Item	No.
2

CITY OF WESTMINSTER					
PLANNING	Date	Classification			
APPLICATIONS COMMITTEE	9 February 2016	For General Rele	ase		
Report of	Ward(s) involved				
Director of Planning	Lancaster Gate				
Subject of Report	12 Garway Road, London, W2 4NH,				
Proposal	Excavation of basement extension under house and part of front and rear gardens, demolition and rebuilding of rear glazed conservatory at lower ground floor, enlargement of front lightwell with new glazed floor and clerestory windows, removal of tree to rear and internal alterations.				
Agent	Savills				
On behalf of	Mr & Mrs Marco Arosio				
Registered Number	15/09360/FULL & 15/09361/LBC	Date amended/	7 October 2015		
Date Application Received	7 October 2015	completed	7 October 2015		
Historic Building Grade	II				
Conservation Area	Bayswater

10. KEY DRAWINGS

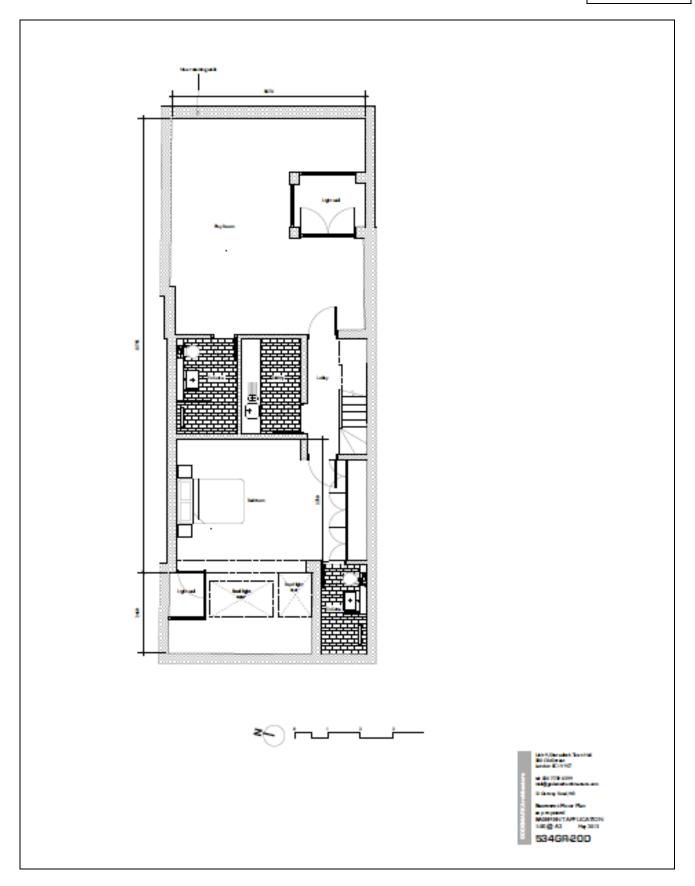
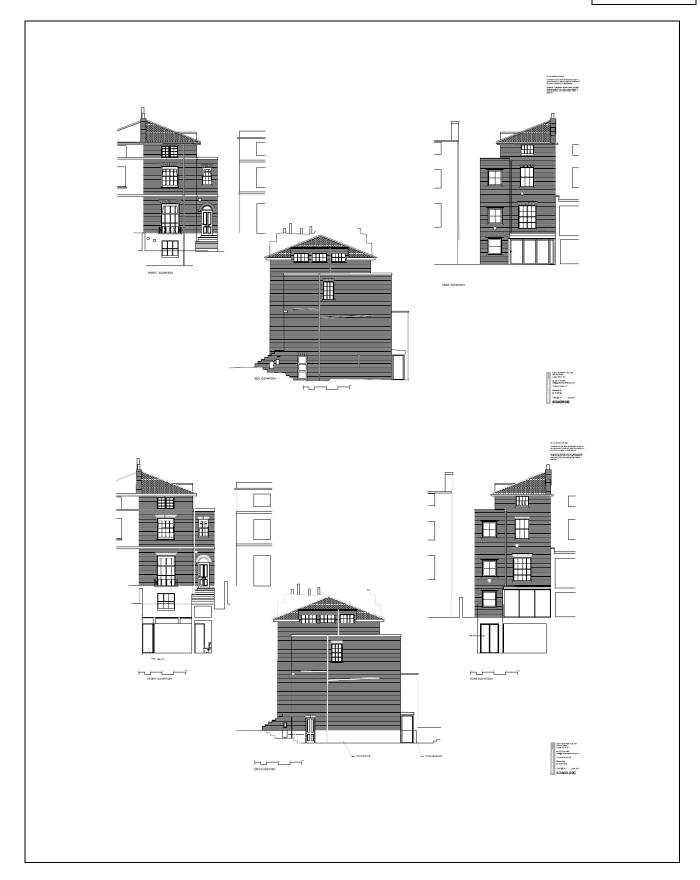
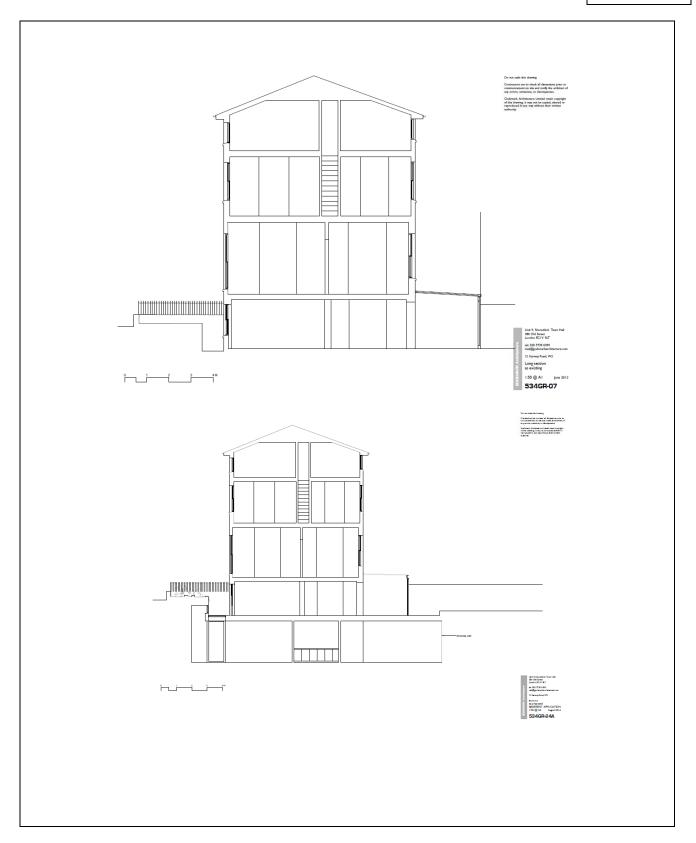
The visual impact of the proposed front lightwell on the buildings setting remains a concern in the current application, as it has not been adequately mitigated by hard or soft landscaping in the submitted scheme. In addition the enlarged lightwell would differ in form the design to that No.14.

The proposed lightwell would project 1.35 metres into the front garden, as opposed to 0.9 metres at present. By increasing its depth (the projection into the garden), the proposed glazing and grille within it would be more prominent in the setting of the building. The use

of clear glazing spanning the depth of the lightwell would create a visually prominent feature with a shiny finish and that impact would be exacerbated by presence of the adjacent clerestory window within the retaining wall of the lightwell. A clerestory window projecting from the garden would be an alien and discordant element, distracting from the attractive front garden, which of course is a more typical setting of a suburban villa of the 1830's.

Because of the form, design and materials of the front lightwell with clerestory windows, the basement excavation would harm the appearance and settings of these grade II listed buildings (No's.12 and 14). It would also fail to maintain or improve (preserve or enhance) the character and appearance of the Bayswater Conservation Area. This would not meet S25 and S28 of Westminster's City Plan: Strategic Policies adopted November 2013 and DES 1, DES 5, DES 9 and DES 10 (A) and paras 10.108 to 10.146 of our Unitary Development Plan that we adopted in January 2007. The works are also contrary to adopted and published guidance contained in our Supplementary Planning Document 'Basement Development in Westminster' (2015).

Required amendments: Revising the design of front lightwell, omitting the clerestory and introducing a grille rather than glazing in the floor of the lightwell. It is recommended that consideration is also given to creating a positive symmetry with No. 14.
